46-52 Nicholson Street and 59-67 Christie Street, St Leonards – Gateway Determination Report

Greater Sydney, Place and Infrastructure

March 2021

Department reference number: IRF21/594

Figure 15: Indicative setbacks and floor plate dimensions (source: Architectus).

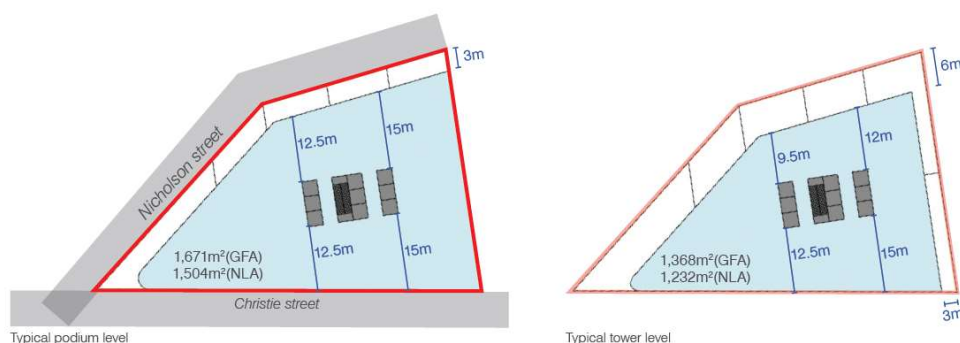
The setback along Christie Street is proposed to be 0m, while the 2036 Plan recommends a 3m setback. The street wall height proposed is 8 storeys along Nicholson Street, with no street wall to Christie Street. The 2036 Plan recommends a 4 storey street wall along both streets.

However, the impact of the non-compliant street setback and street wall height have not been appropriately investigated in the proposal. An updated Concept Design within the proposed building height of RL 175.2 and 15:1 FSR is to be prepared prior to exhibition providing further investigation of these inconsistencies with the 2036 Plan and their potential impacts:

The indicative scheme provides a 0m setback to Christie Street which is contrary to the 2036 Plan's recommendation of 3m. The street wall height proposed is 8 storeys along Nicholson Street, with no street wall to Christie Street. The 2036 Plan recommends a 4 storey street wall along both streets.

As previously discussed, the impacts of the non-compliant street setback and street wall height have not been properly investigated in the planning proposal. An updated Concept Design within the proposed building height of RL 175.2 and 15:1 FSR is to be prepared prior to exhibition providing further investigation of these inconsistencies with the 2036 Plan and their potential impacts.

In relation to the setback and street wall height variations, it is recommended an updated Concept Design be prepared prior to exhibition to provide further justification of these inconsistencies with the 2036 Plan and recommendations for strategies to mitigate any additional adverse impacts to the public domain resultant of these non-compliances.

The planning proposal and indicative concept design requires further justification and recommendations for strategies to mitigate any additional adverse impacts to the public domain resultant of these non-compliances. The Concept Design is recommended to include a landscape concept to illustrate how public domain could be delivered to mitigate any amenity impacts along the streetscape.

Figure 17: View sharing analysis comparing the current 26 storey scheme (Option 3) with the previous 32 storey scheme (Option 1) (source: Architectus).

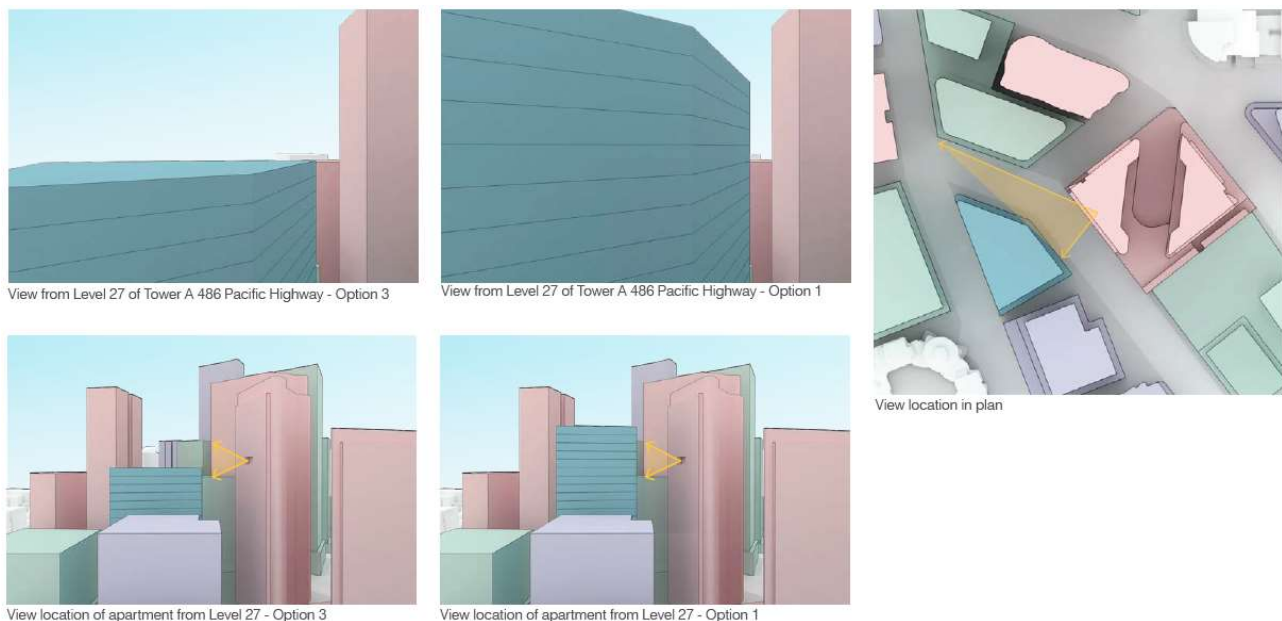
Figure 17 illustrates how Council's 26 storey scheme enables further opportunities for view sharing from 486 Pacific Highway (Tower 2), when compared to the original 32 storey scheme. The Urban Design Analysis (**Attachment 14**), prepared by Architectus, notes that the top ten storeys of Tower 2 will have views over the proposal, while only the top four storeys would have views in the previous 32 storey scheme.

However, it is recommended as part of an updated Concept Design, an assessment of the extent of view loss from a broader sample of residential developments be provided to provide a better understanding of view impacts for surrounding developments.
